STAFF REPORT
COMMUNITY DEVELOPMENT DEPARTMENT

HEARING DATE: 12/6/2022
TO: Mayor & City Council
FROM: Sonya Allen, Associate Planner
208-884-5533
SUBJECT: FP-2022-0033
Prescott Ridge No. 3
LOCATION: West side of N. Rustic Oak Way,
approximately ¼ mile south of W.
Chinden Blvd./US 20-26, in the NW ¼
of Section 28, Township 4 North.,
Range 1 West.

Final plat consisting of 78 single-family residential building lots for detached homes and 13 common lots on 6.82 acres of land in the R-8 zoning district for the third phase of Prescott Ridge Subdivision.

B. Final Plat (date: 10/5/2022)

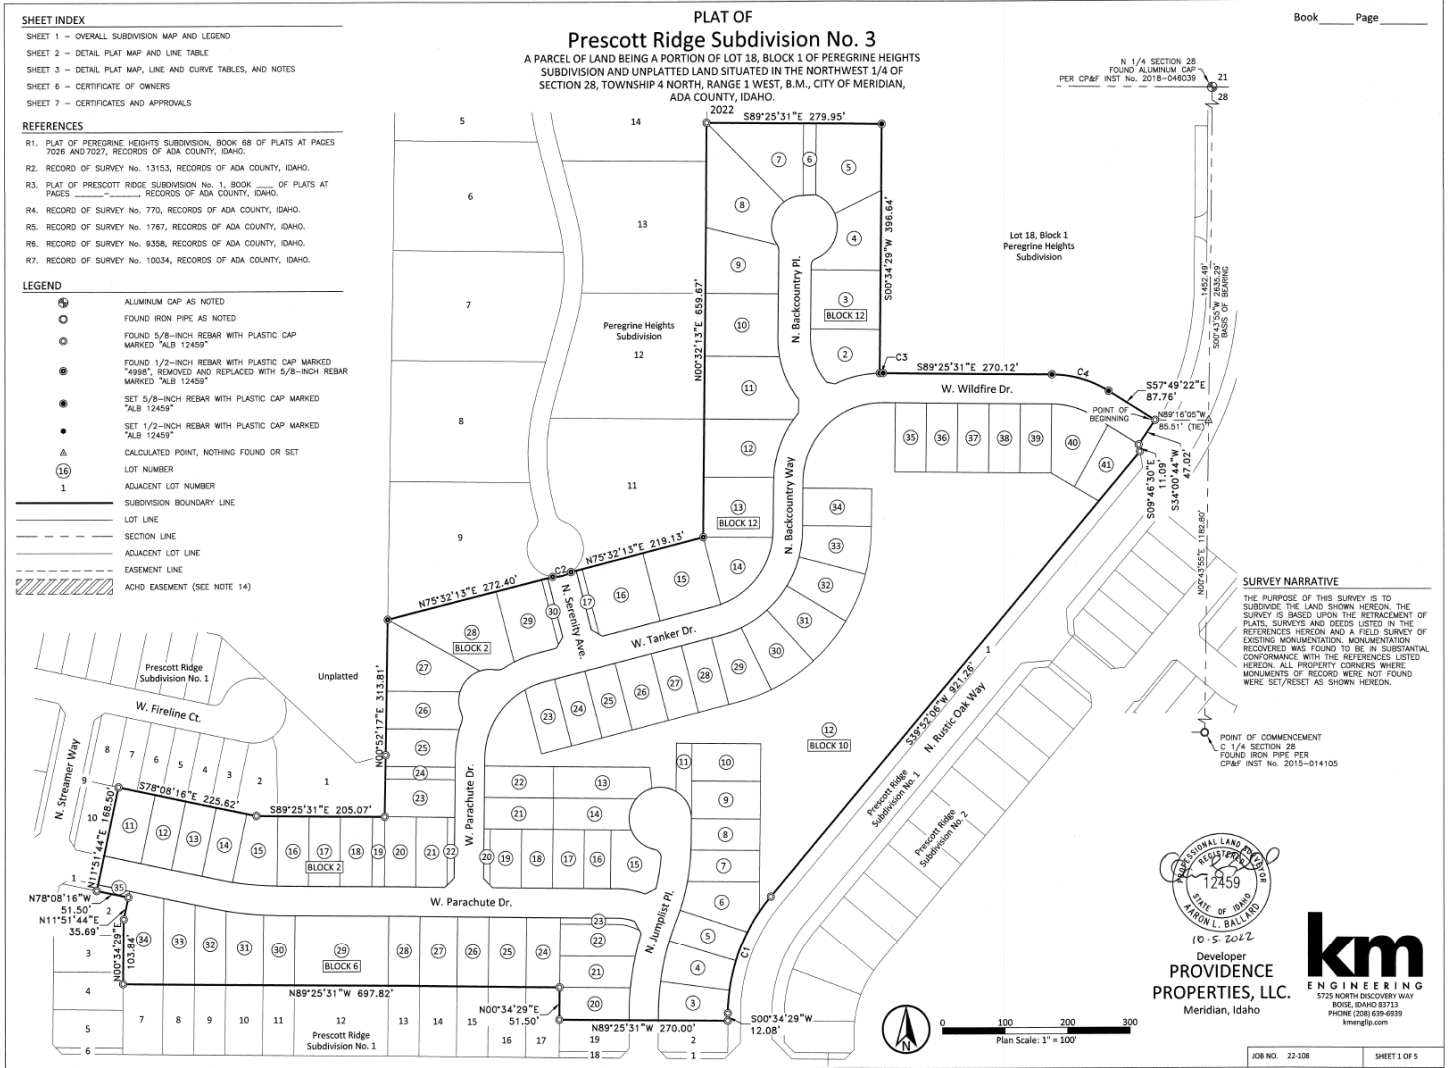
3. Prior to submittal for the City Engineer's signature, have the Certificate of Owners and the accompanying acknowledgement signed and notarized.
4. The final plat shown in Section V.B prepared by KM Engineering, stamped on 10/5/2022 by Aaron L. Ballard, shall be revised as follows:

- a. Note #5: Correct lot and block numbers to coincide with this plat.
 - b. Note #15: Include the recorded instrument number for the ACHD permanent easement.

- c. Note #16: Include the recorded instrument number for the ACHD permanent easement (or delete note if this is a duplicate of note #15).
 - d. Under References, R3 – include the Book and Page numbers of Prescott Ridge Subdivision No. 1.

- e. If the medical facility property to the north isn't able to obtain an access easement for emergency access via Serenity Lane, a private street in Peregrine Heights subdivision to the west, a minimum 20-foot wide emergency access driveway constructed to Fire Dept. standards shall be depicted between Lots 5 and 7, Block 12. *Note: The emergency access isn't required to be functional until the overall area of the building on the site to the north exceeds 124,000 square feet or three (3) or more stories in height; however, the access should be planned for and constructed with the subject plat.*

An electronic copy of the revised plat shall be submitted prior to signature on the final plat by the City Engineer.
